- 10. Fort Raymond Subdivision Replat Number 6  
KPB File 2023-109  
AK Lands / City of Seward  
Location: Sea Lion Avenue  
City of Seward**

**ITEM #10 - PRELIMINARY PLAT  
Fort Raymond Subdivision Replat No 6**

<b>KPB File No.</b>	2023-109
<b>Plat Committee Meeting:</b>	December 11, 2023
<b>Applicant / Owner:</b>	City of Seward / Seward, AK
<b>Surveyor:</b>	Stacy Wessel / AK Lands Land Surveying
<b>General Location:</b>	Sea Lion Avenue, City of Seward

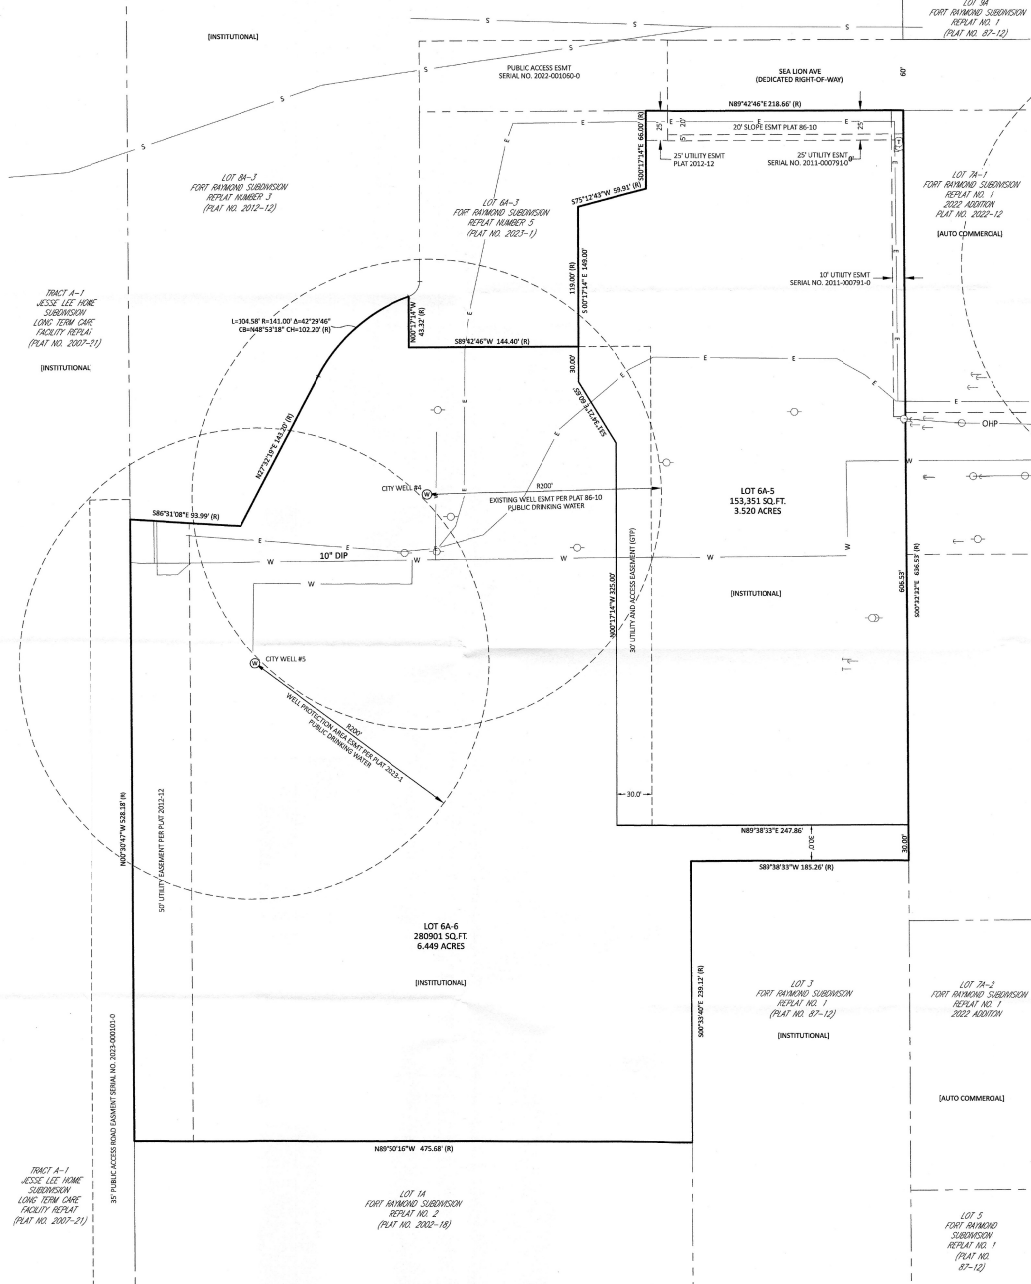
In the legend, add icon for wells.  
Add to KPB No. 2023-109

**Staff recommendation:**  
Need to verify the public access easement width on the west side of plat.
- D. A vicinity map, drawn to scale showing location of proposed subdivision, north arrow if different from plat orientation, township and range, section lines, roads, political boundaries, and prominent natural and manmade features, such as shorelines or streams;

**Staff recommendation:**  
Add north arrow to vicinity map  
Depict the city limits  
Relabel Fourth Ave to Third Ave.  
First Ave should be Vista Ave it appears

**Staff recommendation:**  
Lot 3 & 5 to the east needs correct plat labels.  
Lot 7A-2 needs a plat label.  
Zoning label on lots is not needed and can be removed.

- J. Block and lot numbering per KPB 20.60.140, approximate dimensions and total numbers of proposed lots;  
**Staff recommendation:**  
Zoning labels in the lots are not needed and can be removed unless requested by City of Seward.

Unsure of access easement on west as description excludes existing utility easement. Surveyor should verify legal description

Is Certificate of Acceptance needed on the plat. Staff did not see any public access easements, ROW or other public areas not already public owned, please verify need and list in Certificate if found.

Ad the date of December 11, 2023 to the Plat Approval.

**Staff recommendation:** Place the following notes on the plat.

- The borough will not enforce private covenants, easements, or deed restrictions per KPB 20.60.170.
- place the standard note on the plat for the flag lot(s): No structures are permitted within the panhandle portion of the flag lot(s).
